DOCUMENT 00 90 00
ADDENDUM

ADDENDUM No.: 1

RE: ST. PAUL'S LUTHERAN CHURCH STAIR REPLACEMENT
401 MILL STREET
WILTON, WISCONSIN 54670
PROJECT NO. 22025

FROM: HSR Associates, Inc
100 Milwaukee Street
La Crosse, WI 54603
(608) 784-1830

C500

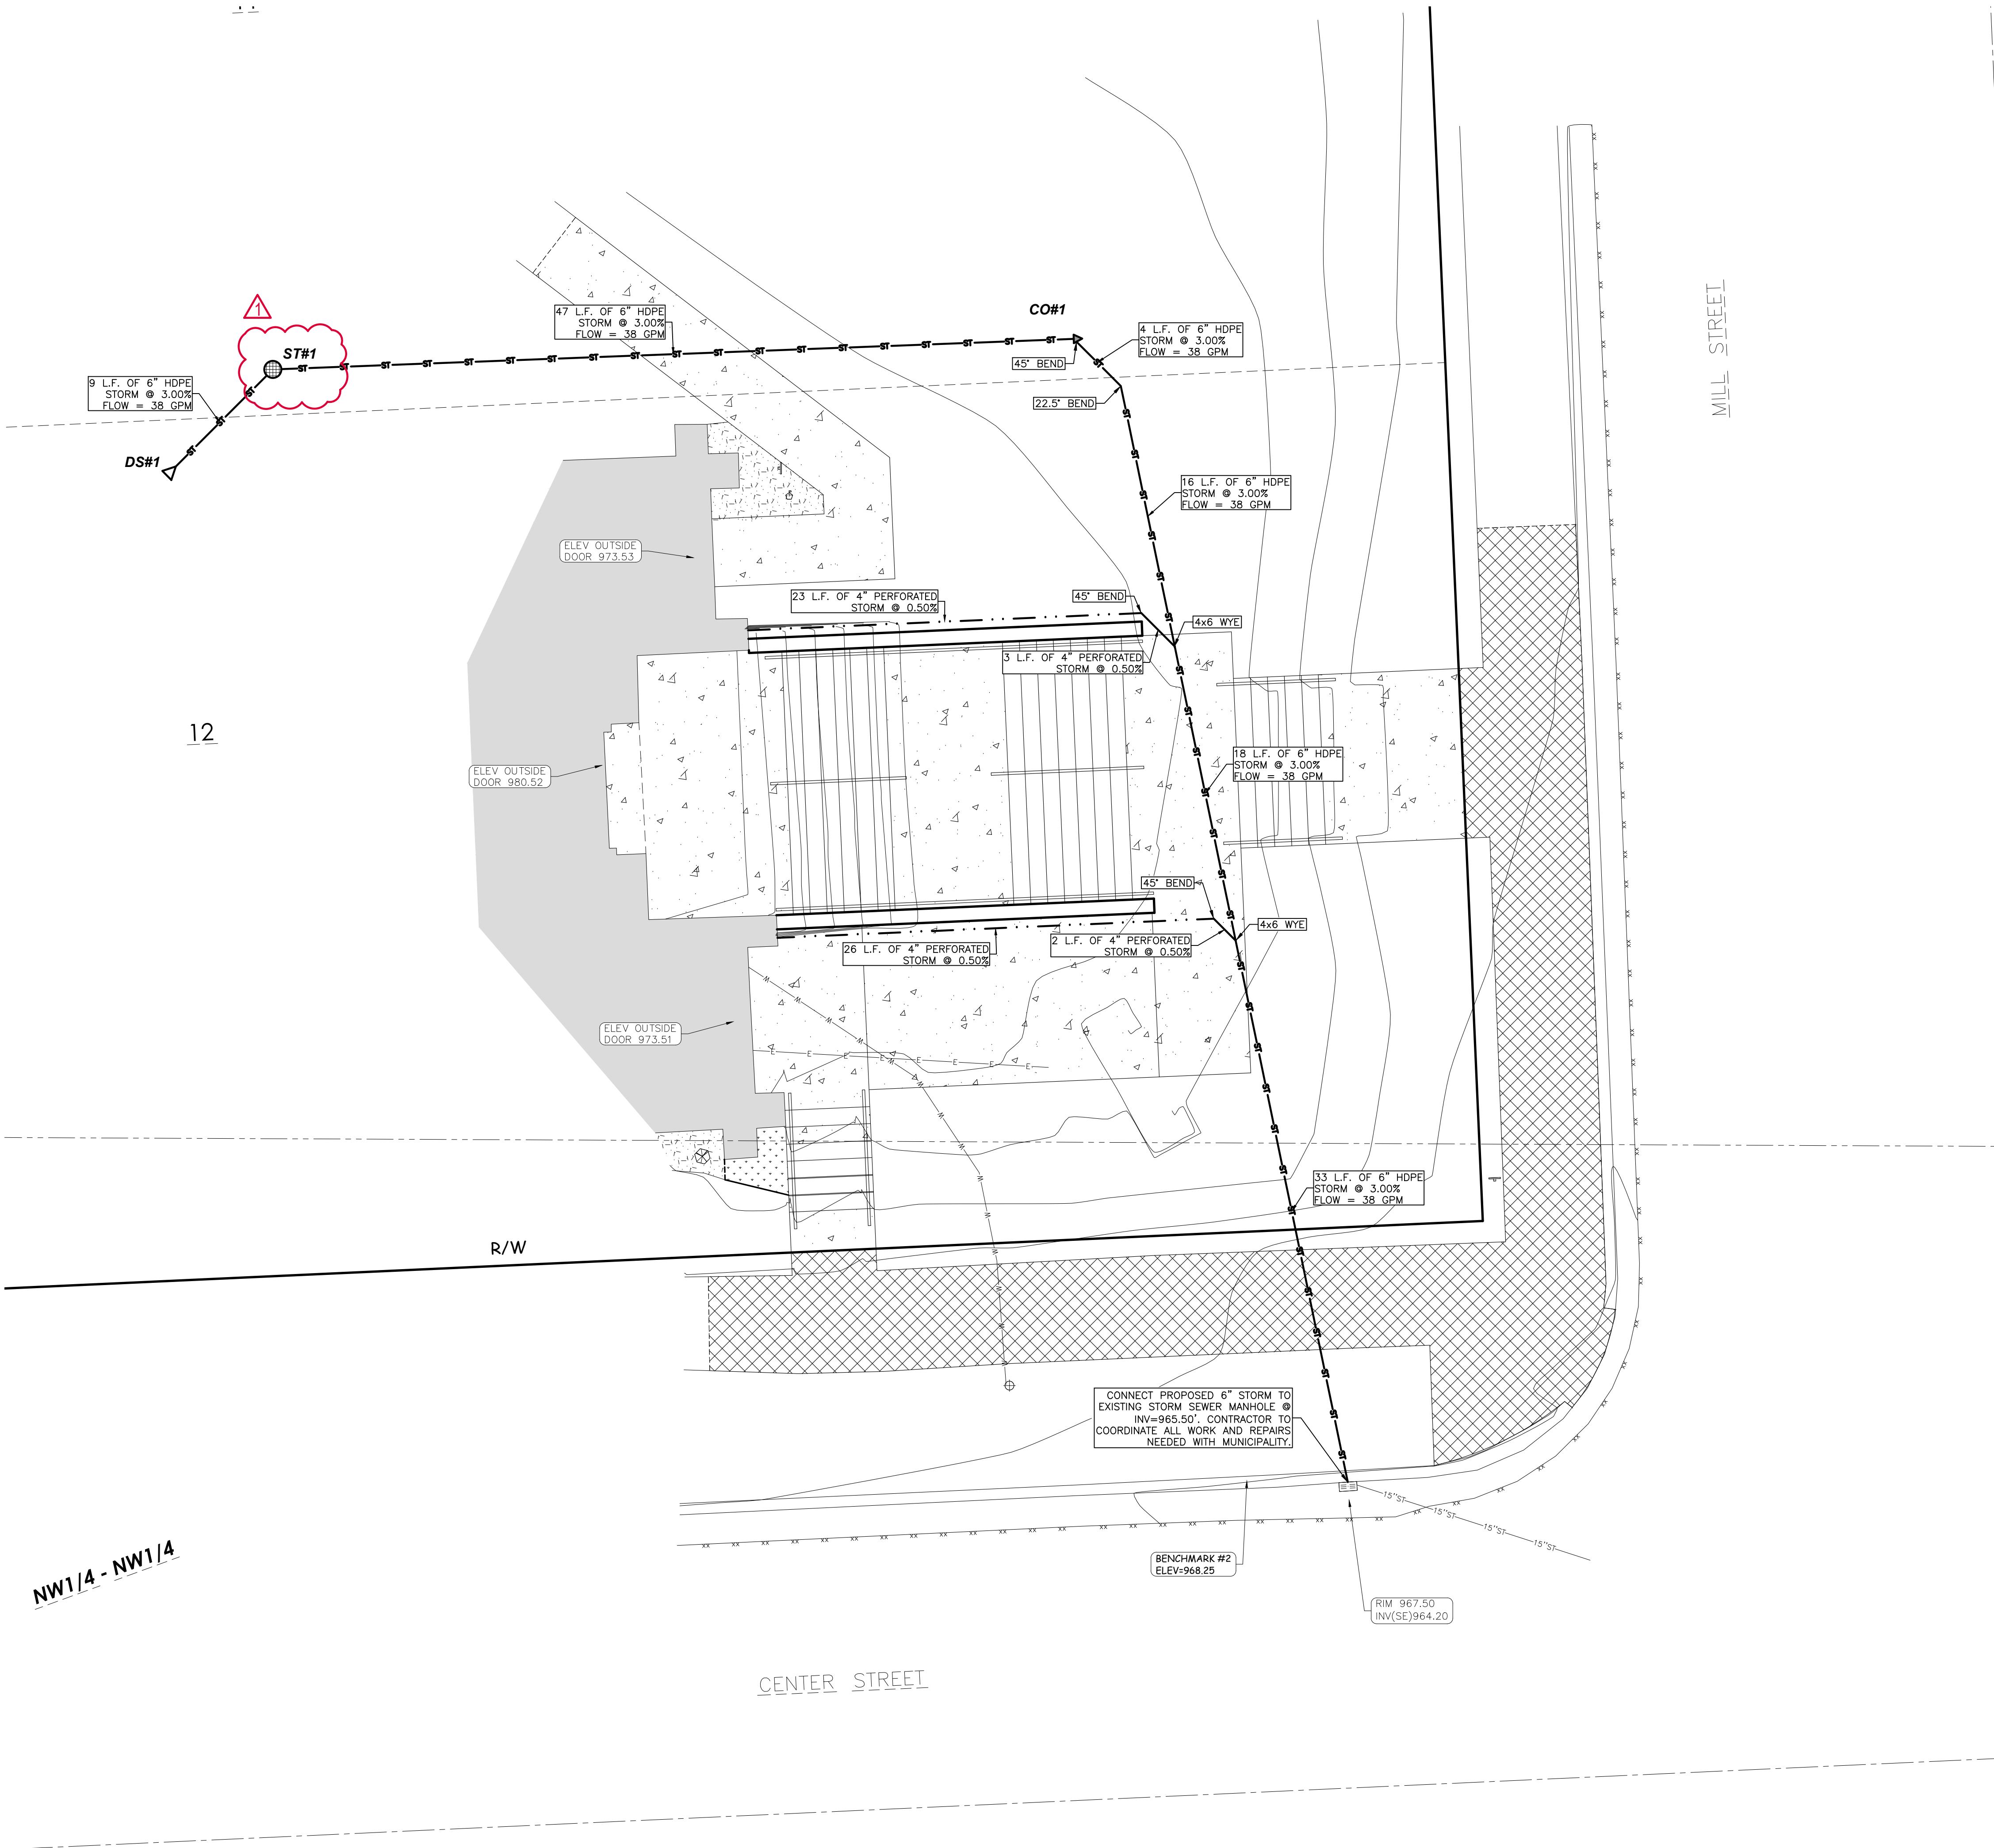
2. Sheet C500 UTILITY PLAN 30"x42"
 - a. See the revised sheet included in this addendum. Disregard the previous version.
 - b. Add storm structure. See clouded changes.
